Answers

Re: FCC ID PPIRM-77XH

Applicant: Nokia GmbH
Correspondence Reference Number: 29544

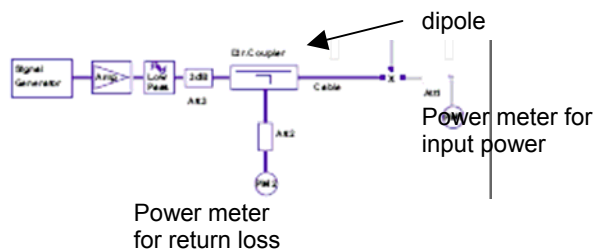
- 8) Please provide full details of the scan setup including resolutions, and dwell and integration times.
 - Measurement step size is 5mm, measurement time 0.5s, zeroing time 0.5s and zeroing period 10s. Measuring time is long compared to burst repetition period.

- The input signal was an unmodulated continuous wave, and average input power = 100mW after adjustment for return loss. The proper measurement of the 1cm probe to dipole separation, which is measured from the top surface of the dipole to the calibration reference point of the sensor, defined by the probe manufacturer. A dipole antenna meeting the requirements in PC63.19 was placed in the position normally occupied by the WD. The length of the dipole was scanned with both E-field and H-field probes and the maximum values for each were recorded.

Setup for desired output power to dipole:
